### Case Information: Z-1-17 – Falls of Neuse Road

## Zoning Staff Report – Z-1-17

SUBJECT: Traffic Impact Analysis Review for Z-1-2017

**Figure 3: Z-1-2017 Level of Service Map for AM Peak North Area**

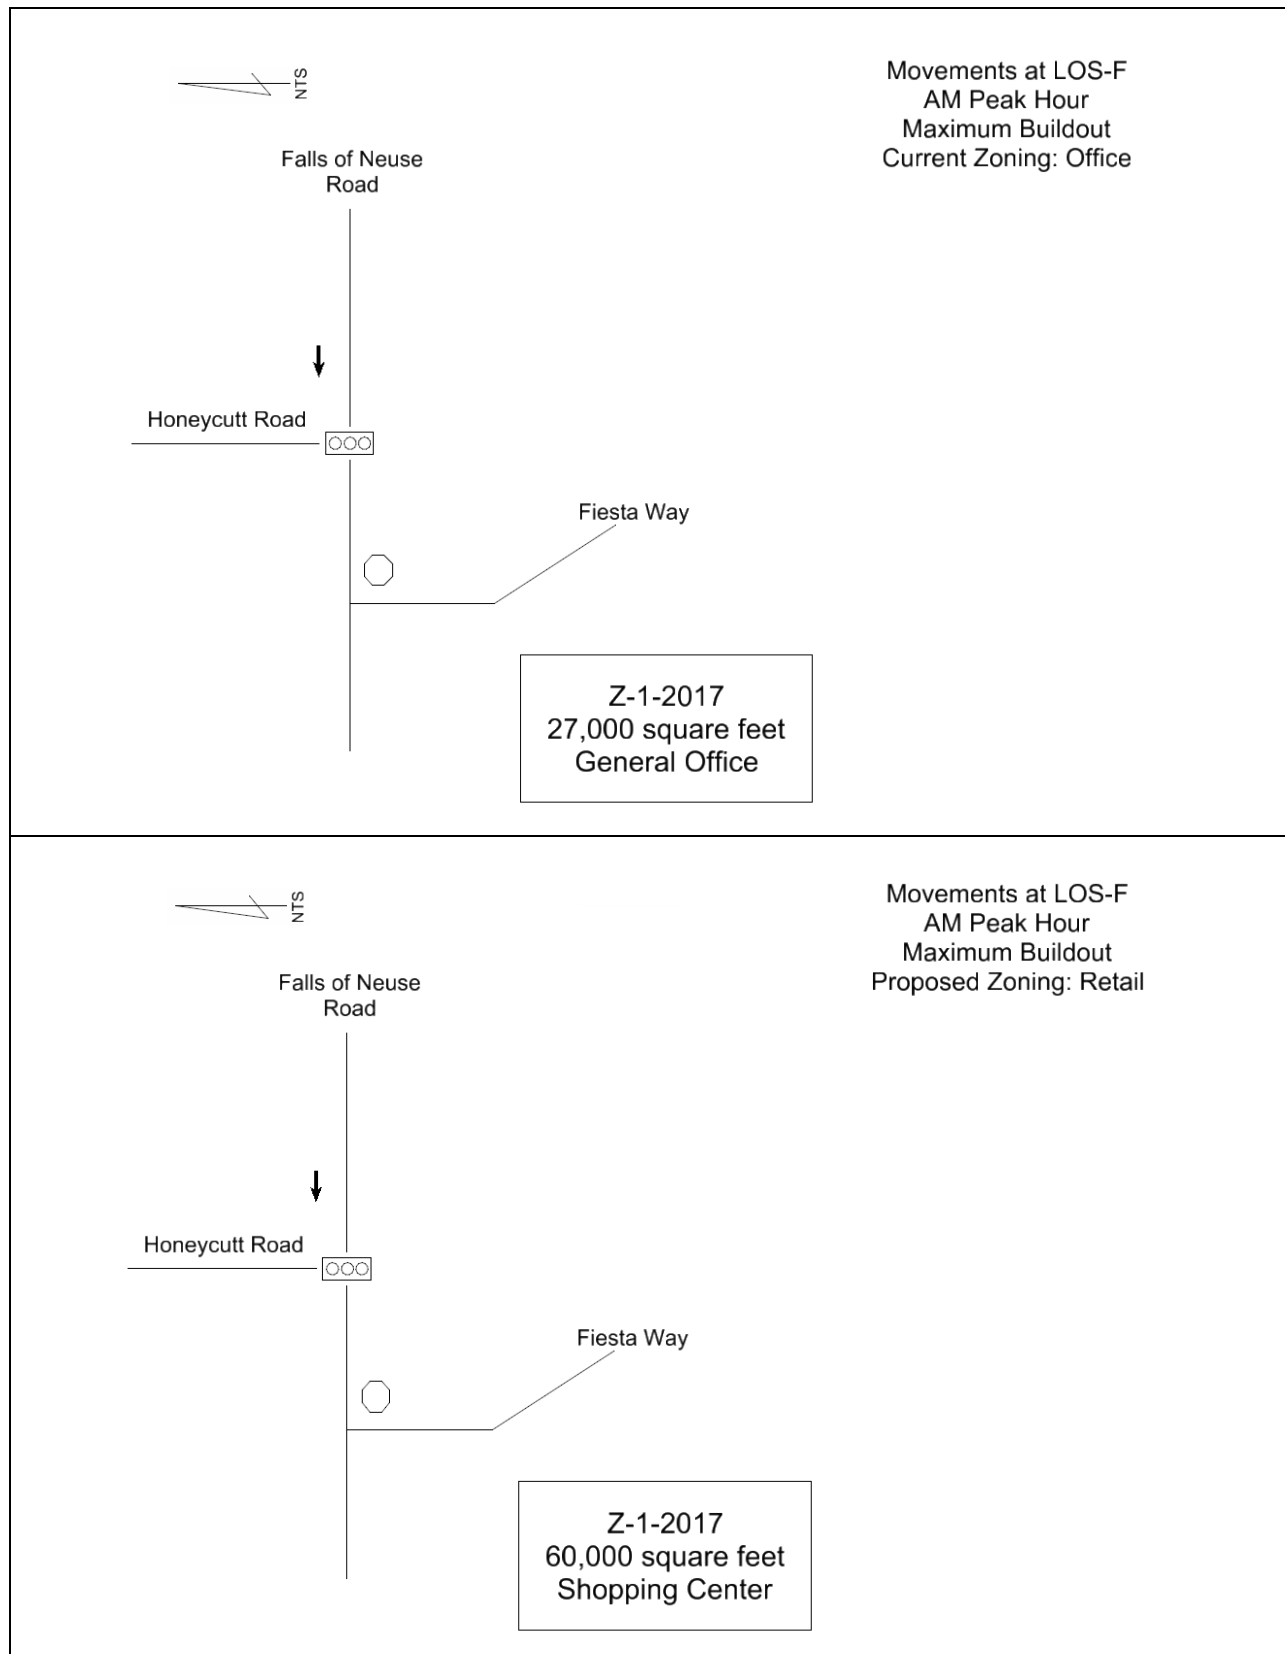
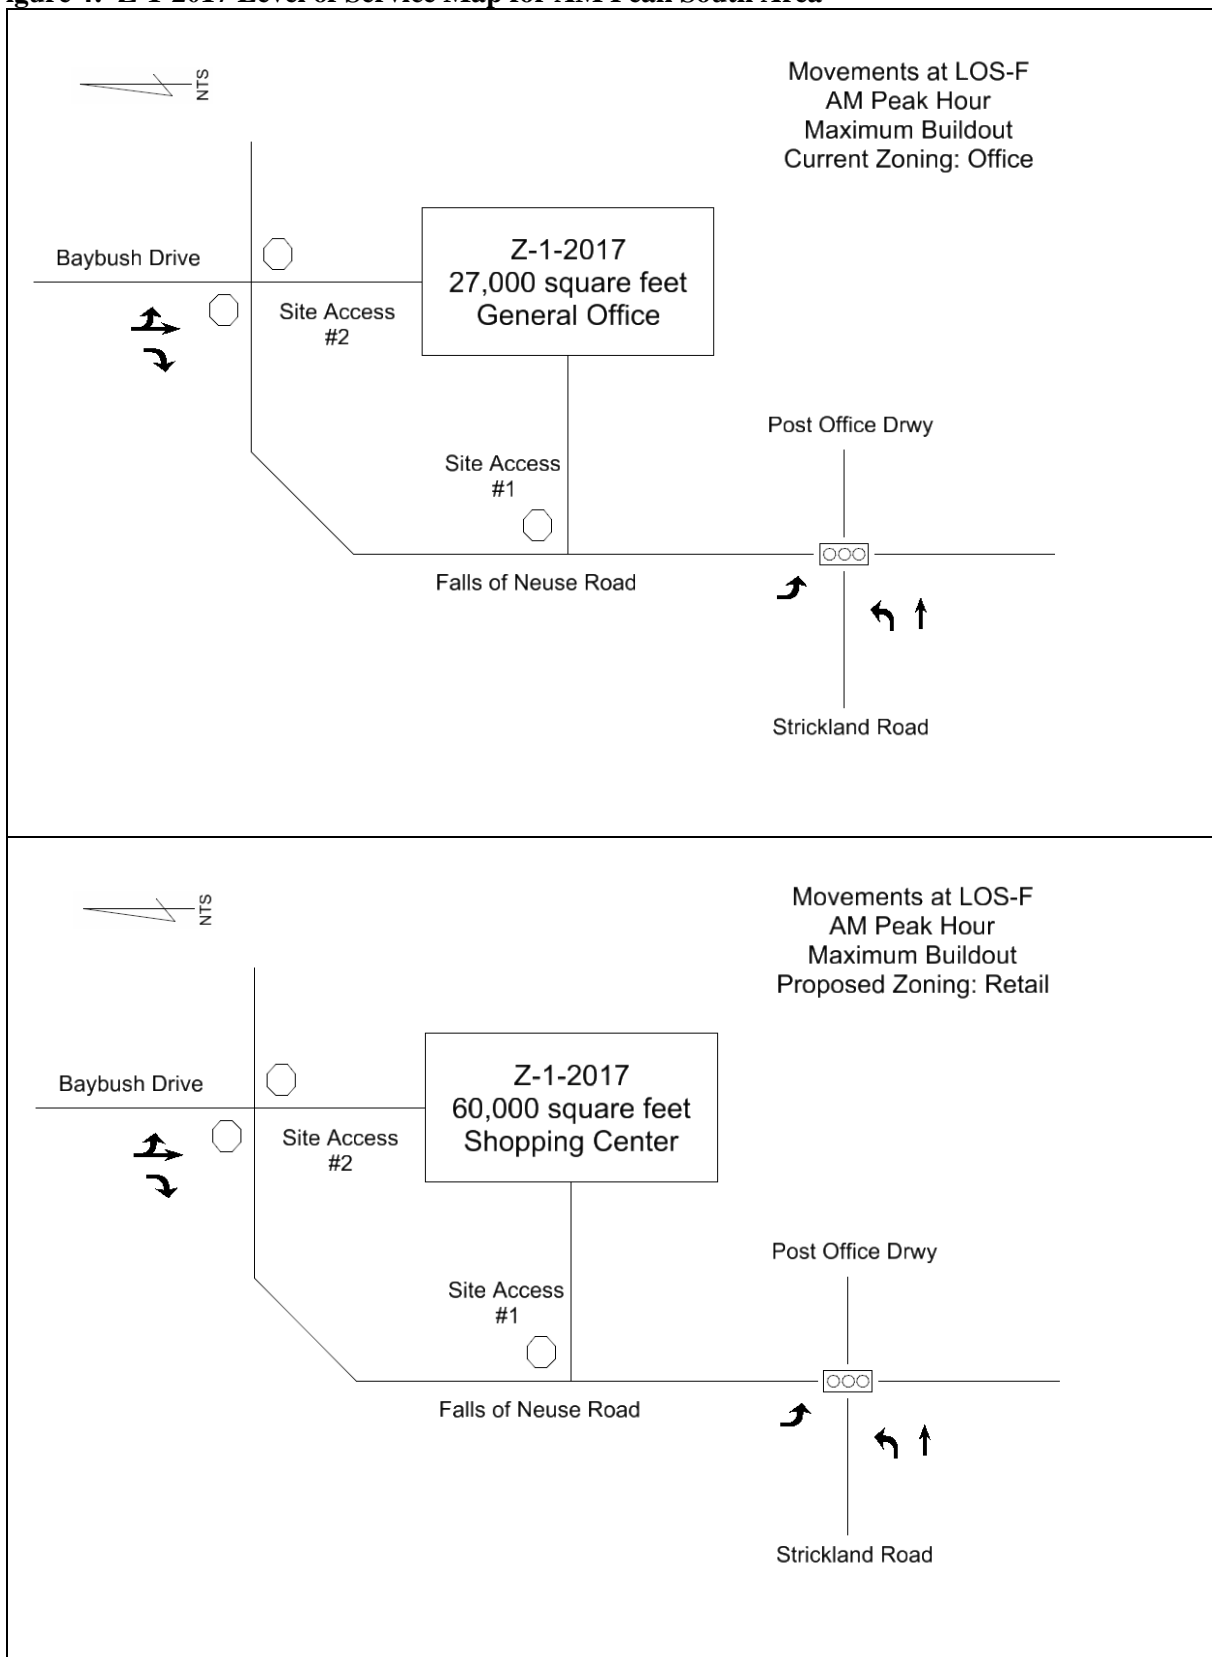
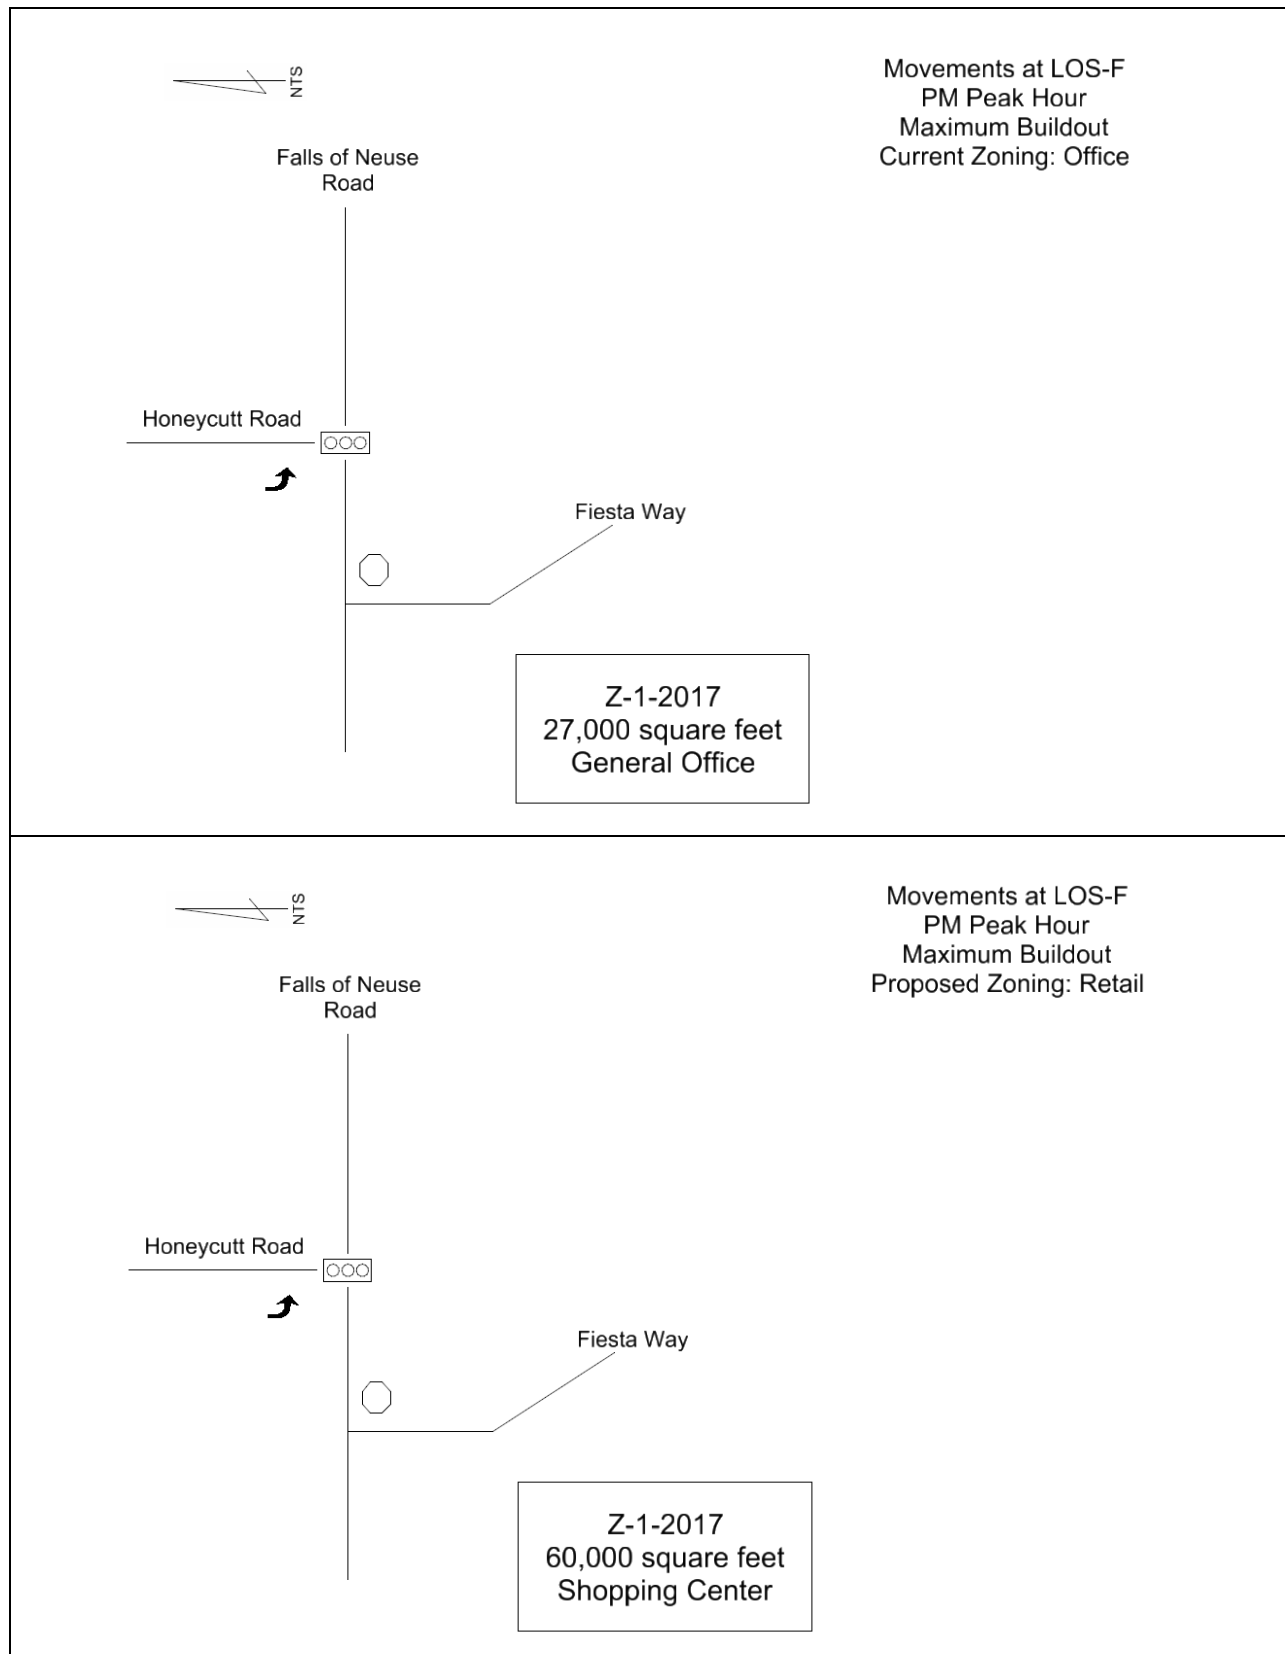
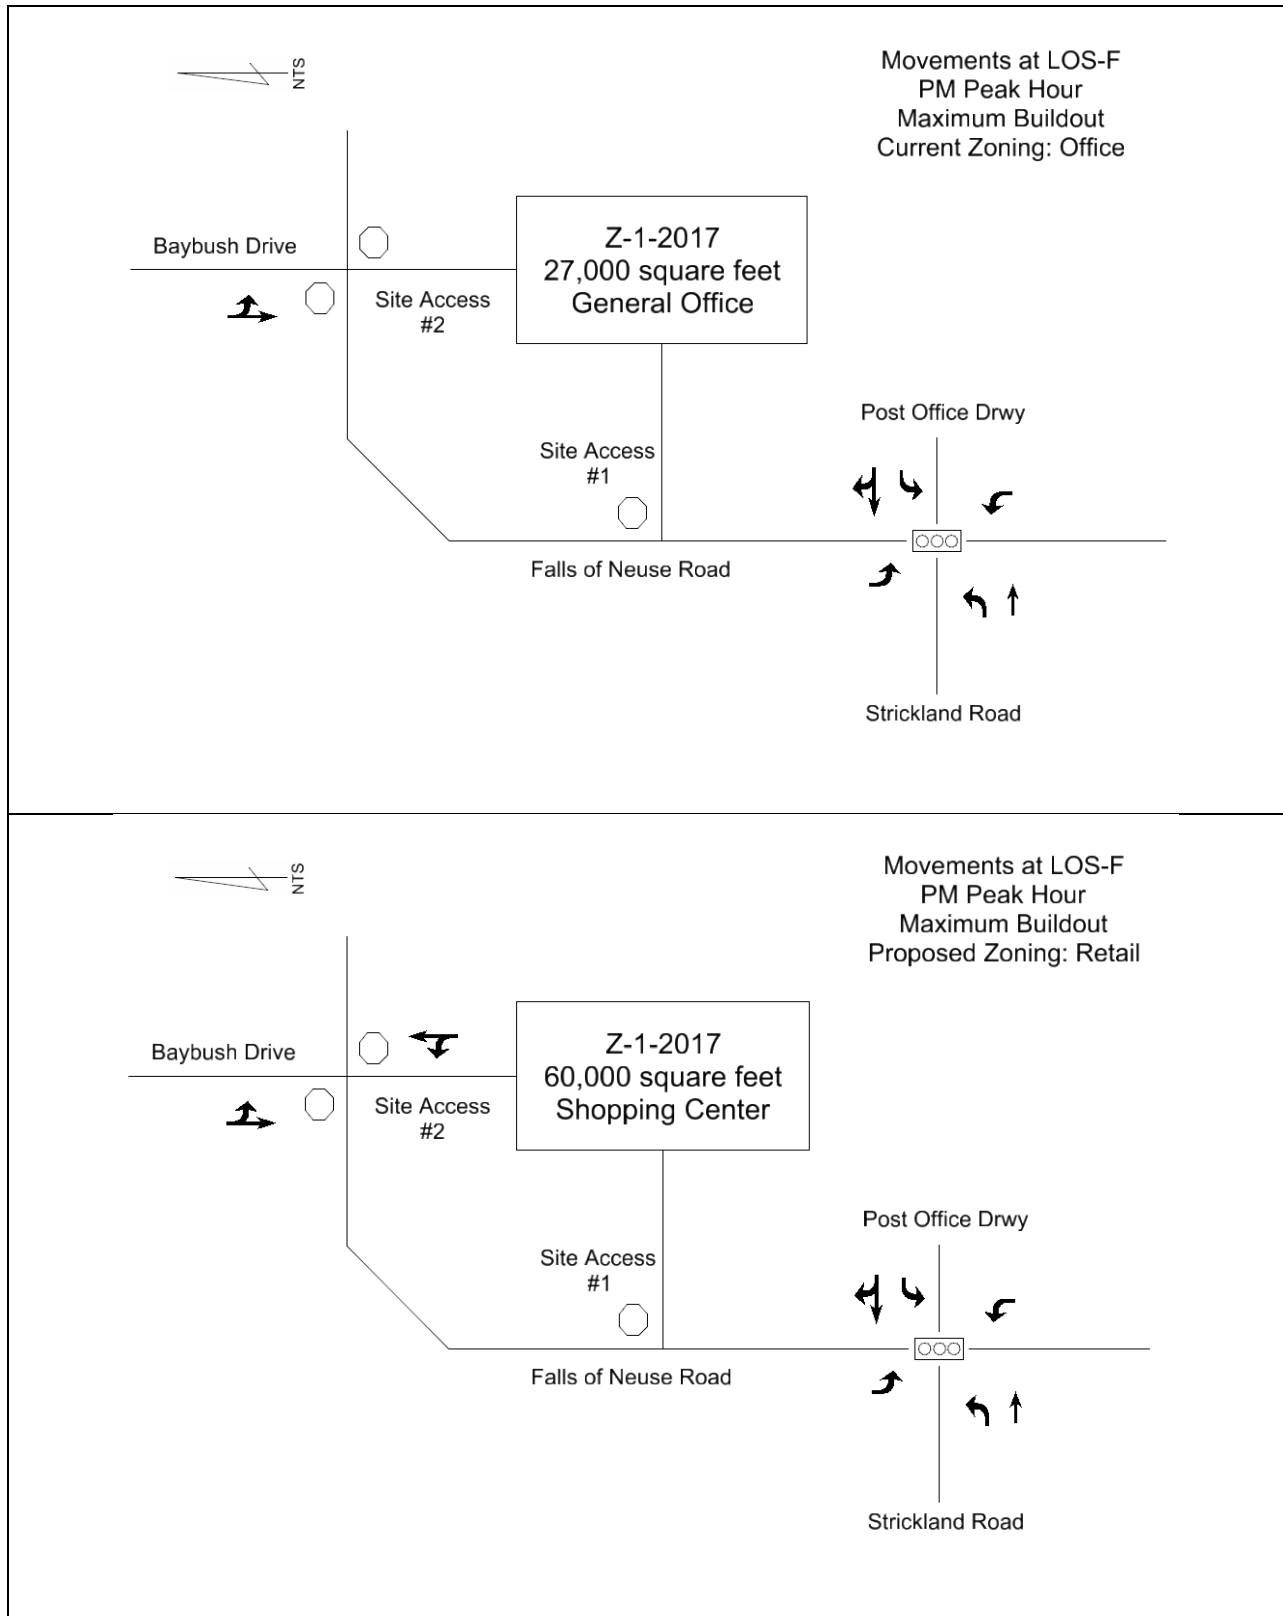
The motorists approaching the stop-controlled intersection on Baybush Drive currently encounter long delays both due to traffic volume on Falls of Neuse Road and due to the uphill slope on that approach. The TIA report acknowledged that rezoning case Z-1-2017 would add to the delay for Baybush Drive, but did not recommend any mitigation or changes to the current traffic control configuration, i.e., the report did not recommend a new traffic signal at the intersection of Baybush Drive and Falls of Neuse Road.

Changes in vehicular traffic volume and traffic delay are not linear: a relatively small increase in vehicular volume can lead to a proportionally larger change in delay and vice versa. Table 3 provides a comparison of the expected changes in traffic volume and delays under current zoning (office use) and proposed zoning (shopping center). Although overall intersection levels of service may not reach LOS F, individual movements are expected to reach LOS F due to current traffic volumes along the Falls of Neuse corridor. Refer to Figures 3 through 6 for those movements with LOS F under the current zoning and proposed zoning scenarios.
